STAFF RECOMMENDATION 1402 Paris Avenue July 18, 2012

Application: New construction - primary building
District: Belmont-Hillsboro Neighborhood Conservation Zoning Overlay
Council District: 18
Map and Parcel Number: 11801007200
Applicant: William Smallman, Owner
Project Lead: Sean Alexander, sean.alexander@nashville.gov

SITE PLAN

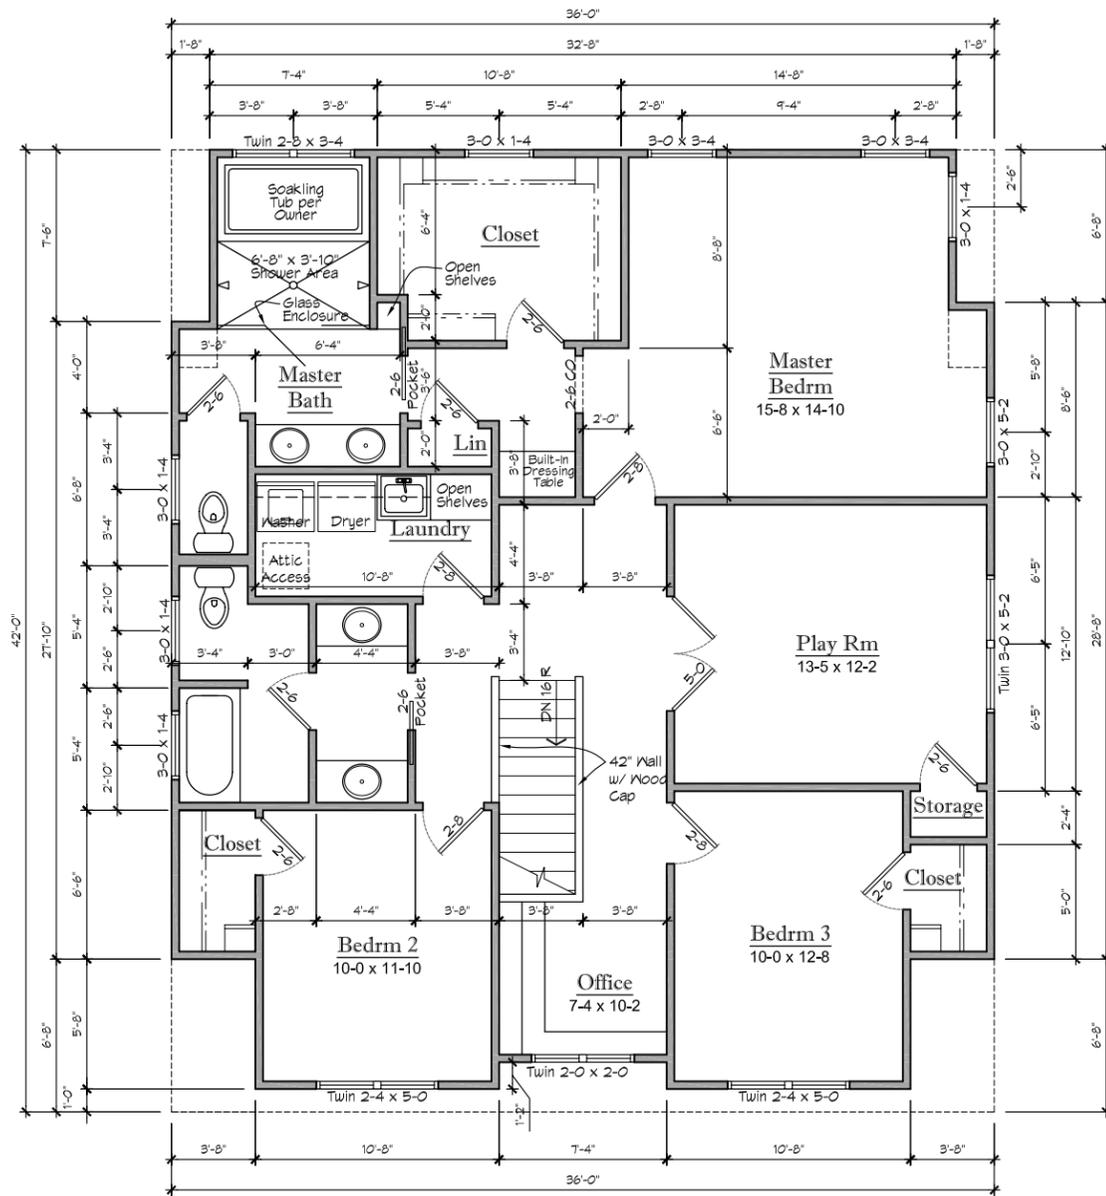
The submitted site plan does not indicate the locations of exterior HVAC units or utility connections. Staff will need to verify they are located so as to minimize their visibility from the street prior to issuing a permit.

Recommendation: Staff recommends approval with the condition that staff review the color and texture of the brick, roofing material design and color, and the location of mechanical and utility connections. With this condition, Staff finds the proposal to meet the Design Guidelines for new construction in the Belmont-Hillsboro Neighborhood Conservation Zoning Overlay.
